## Arboricultural Comment

Tony Peterson  
Contract Properties Pty Ltd  
Job Site: 71 Fig Hill Lane Dunmore

*RE: Onsite inspection for proposed installation of new water line from edge of bitumen Riverside Drive through DP 219199 (adjacent property) into DP717776 and the impacts this may have on any trees that lie within the path of the proposed water line*

Appendix 1: Tree location plan Sheet 1

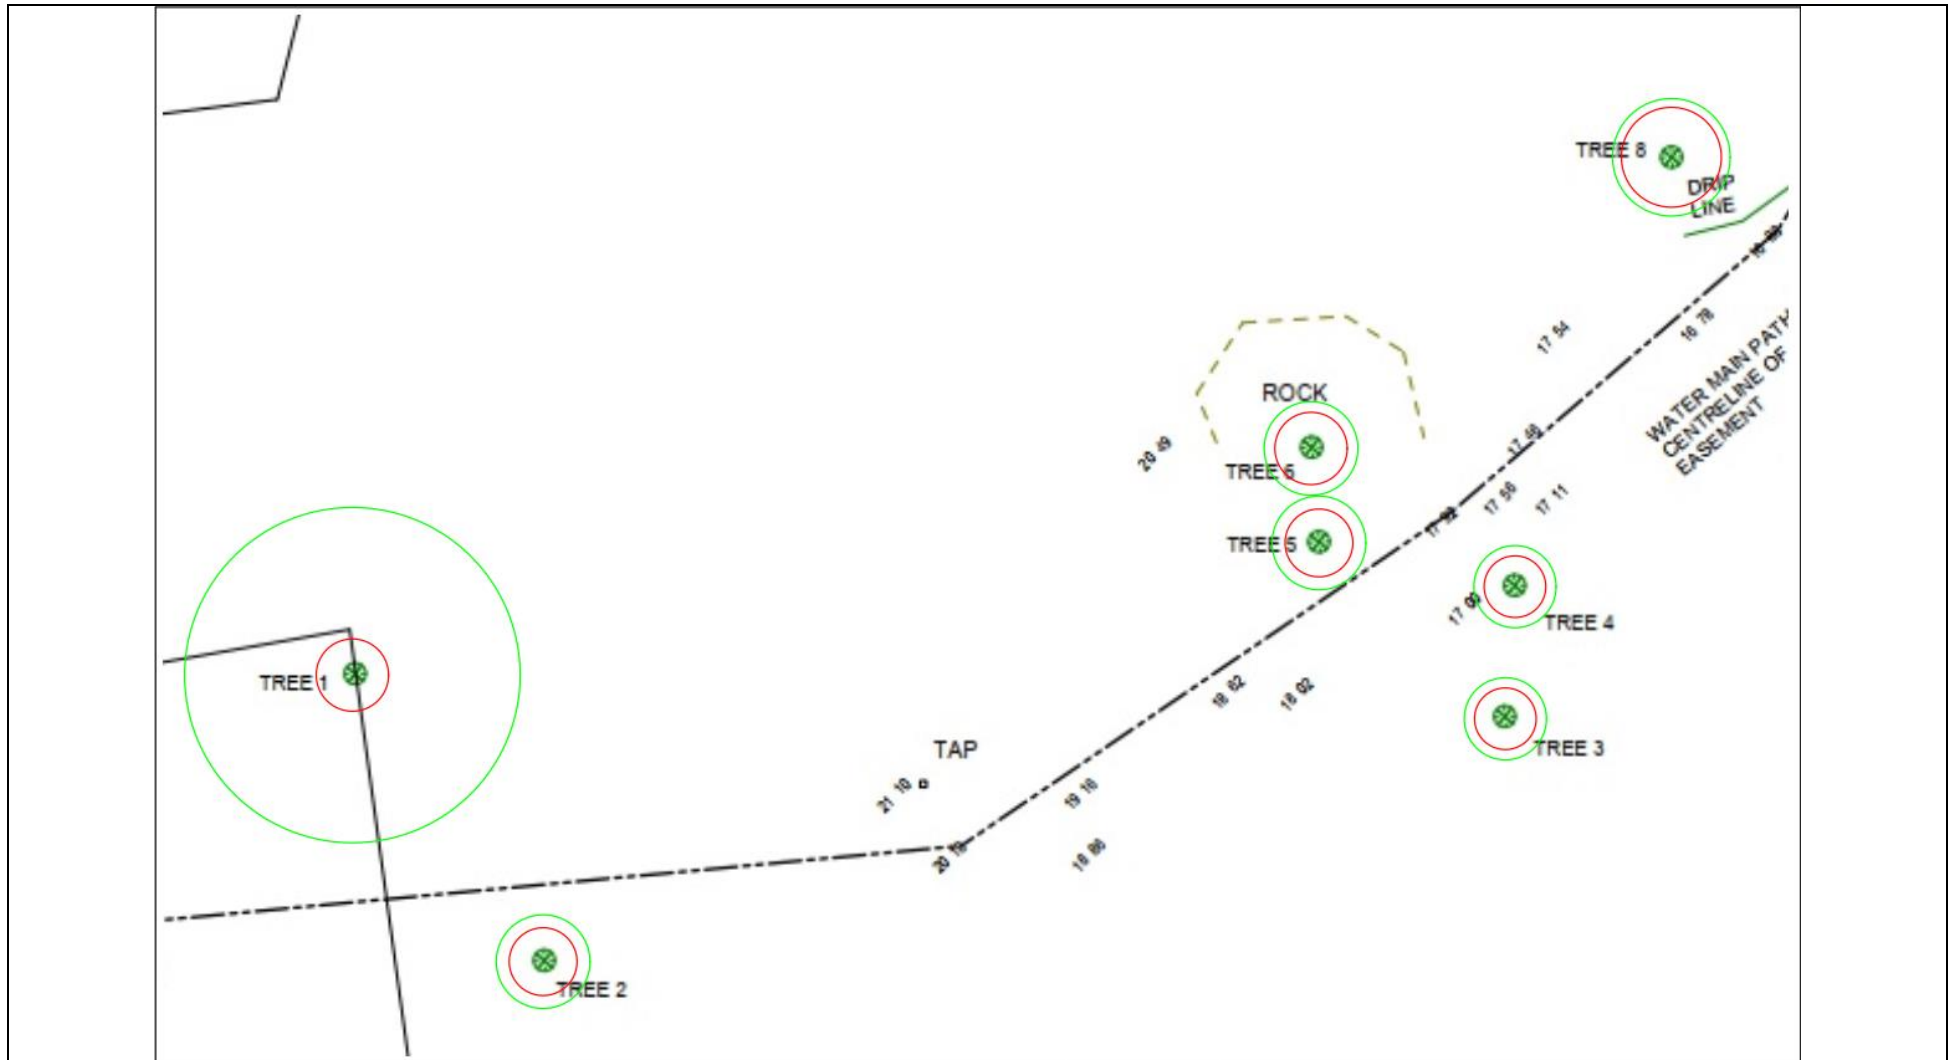
- Seven trees were identified as within adjacent area of the proposed water pipe.
- T1 is located on the boundary of Lot DP717776 and DP 219199.
- T2, 3, 4, 5, 6 and 8 are located on adjoining Lot DP 2191999.
- No encroachments were identified based on tree data collected on site.

- The potential exists for the proposed water line to be placed on the proposed alignment with no impact to existing trees in either DP717776 or DP219199.
- Our Garden Path has prepared this Arboricultural Comment on behalf of Tony Peterson Contract Properties.

Extract from Detail of proposed water pipe alignment by CEH Consulting overlain on survey. Indicative protection zones shown in green have been calculated as per AS4970 scaled and plotted. Red dashed circle indicates Structural Root Zone. All TPZ and SRZ on trees are clear of works.
